Duquesne Light Company

Beaver Valley Power Station
P.O. Box 4
Shippingport, PA 15077-0004

Reference: Beaver Valley Power Station, Unit No. 1 and No. 2
BV Docket No. 50-334, License No. DPR-66
BV-2 Docket No. 50-412, License No. NPF-73
Supplemental Response to Station Blackout Rule -
10CFR50.63

Figure 1
BVPS Unit 1 & 2
AAC Cross-tie

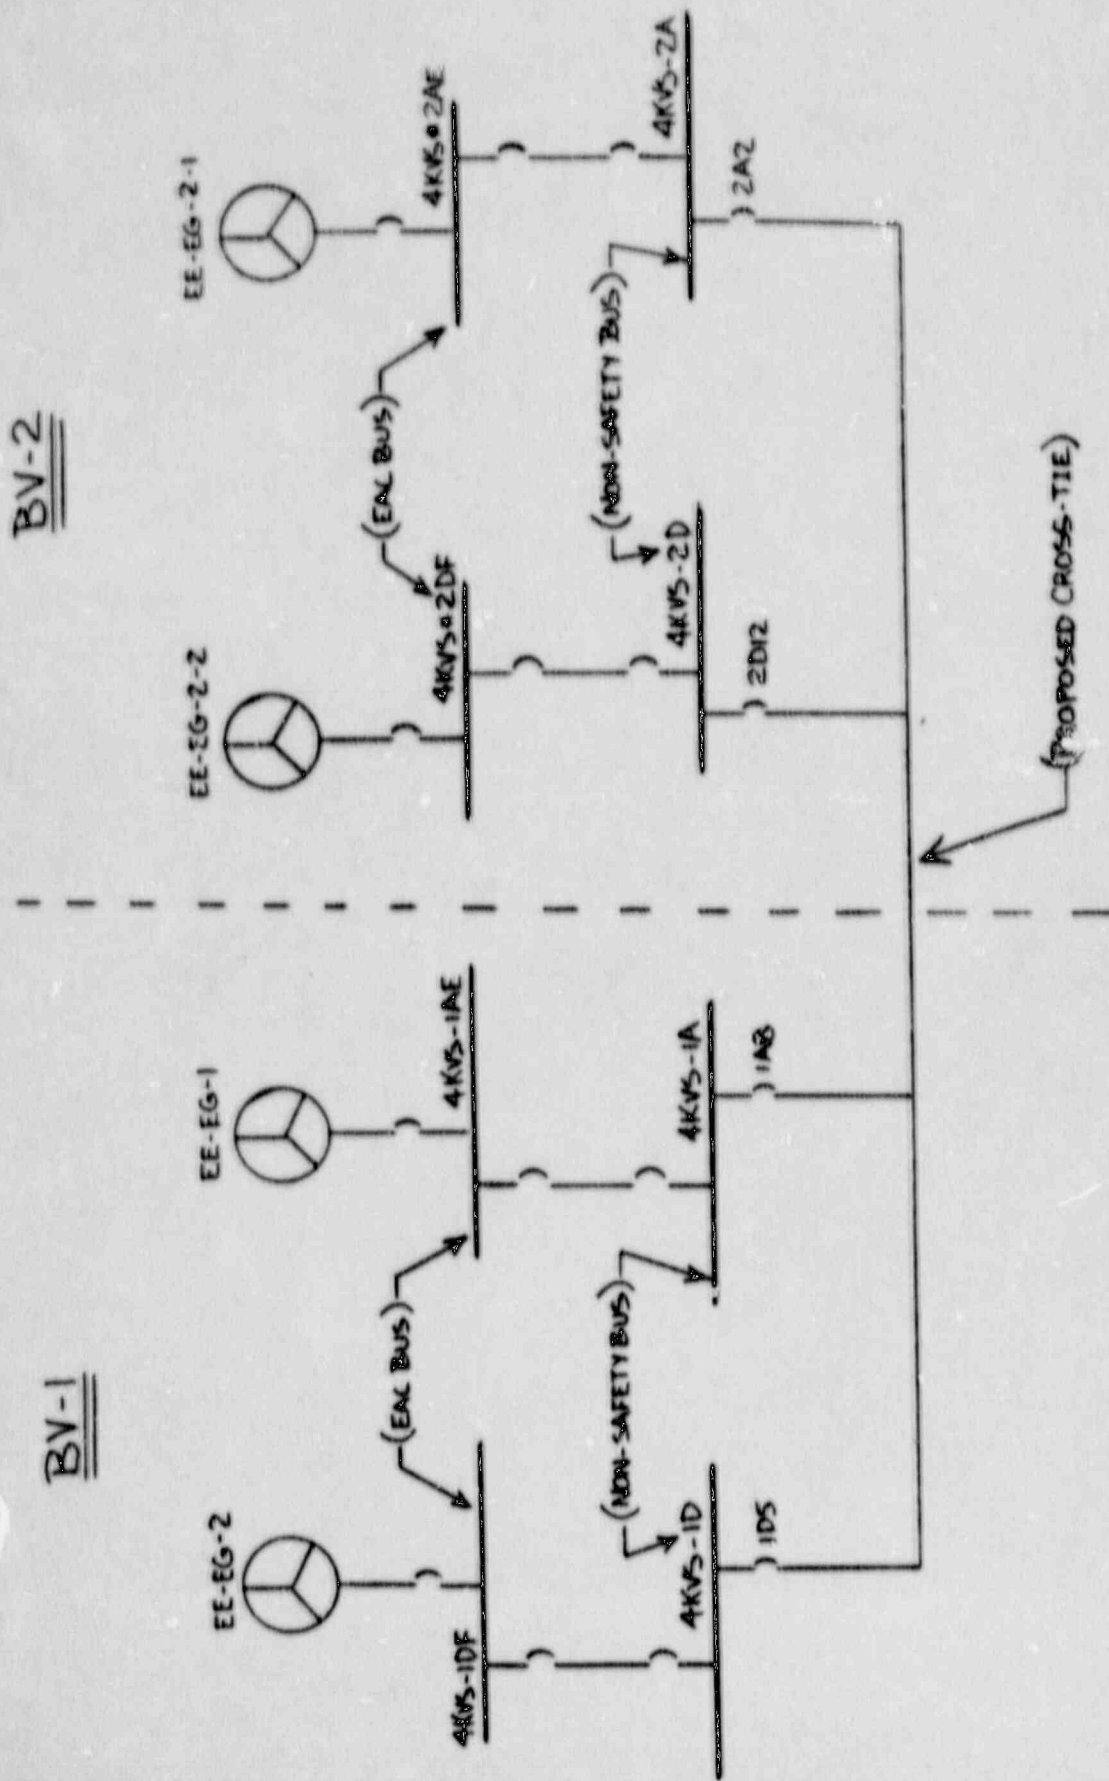
Based on the NUMARC supplemental guidance, our AAC configuration has been revised from our previous submittal (see attached Figure 1). The AAC configuration will utilize a single cross-tie between the Unit 1 and Unit 2 normal 4 KV busses. This change was necessary to meet criterion B.8(e) of NUMARC 87-00 which requires that there be no single point vulnerability whereby a single active failure could disable any portion of the on-site emergency AC power source and simultaneously fail the AAC power source.

The modifications and procedure changes associated with the AAC cross-tie will be completed within two years after the notification provided by the Director, Office of Nuclear Reactor Regulation in accordance with 10CFR50.63(c)(3). Since our Alternate AC (AAC) power source will involve cross-tieing busses between Units 1 and 2, installation and testing will require refueling outages at both units to fully implement the cross-tie capability. Therefore, the schedule for completion may need to be extended, dependent on the NRC approval date and the scheduled refueling outage dates for both Unit 1 and 2. Presently, the schedule for Unit 2's 3rd Refueling Outage is March 1992, and Unit 1's 9th Refueling Outage is September, 1992.
